UNITED STATES PATENT AND TRADEMARK OFFICE

APPLICATION NO.	FILING DATE	FIRST NAMED INVENTOR	ATTORNEY DOCKET NO.	CONFIRMATION NO.
10/518,820	06/23/2005	Gilles Fonteneau	UMC.10019	9970
45473 7590 09/10/2008 BRINKS, HOFER, GILSON & LIONE 2801 SLATER ROAD, SUITE 120 MORRISVILLE, NC 27560				
EXAMINER LAZORCIC, JASON L				
ART UNIT		PAPER NUMBER		
1791				
MAIL DATE		DELIVERY MODE		
09/10/2008		PAPER

Office Action Summary

DETAILED ACTION

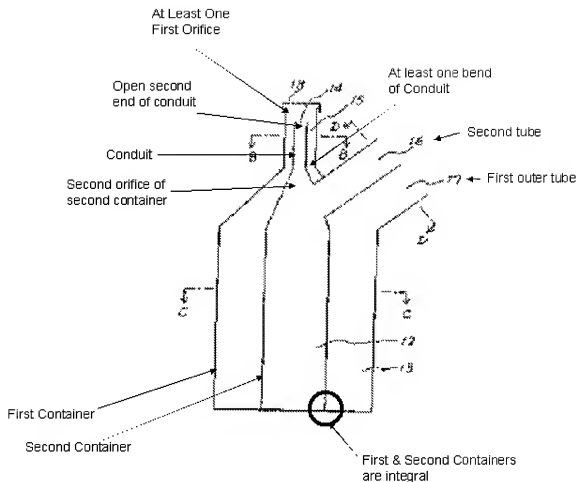
Regarding independent **Claim 1** and with particular reference to the embodiment depicted in the instant reference figures 4a-d (see annotated figure 4a excerpt below), Mitachi teaches a chamber comprising a substantially closed first container (13) which comprises at least one "first orifice" in the region of lead line (15). A substantially closed second container (12) is positioned inside and is integral with the first container. As noted in the figure, a "second orifice" connects the second container to a first end of "a conduit", which conduit is understood to be integral to said second container. This conduit further comprises a "second open end", as noted, which is inside the first container and which is aligned with and at a distance from said first orifice.

Regarding **Claim 14**, the second container and conduit are inside the first container (see fig. 4 excerpt below)

Regarding **Claim 15**, the conduit comprises at least one bend as noted in the figure 4 excerpt

Regarding **Claim 20**, Mitachi teaches a first outer tube (17) as noted in the figure 4 excerpt below

Regarding **Claim 21**, Mitachi teaches a second tube (16) as noted in the figure 4 excerpt.
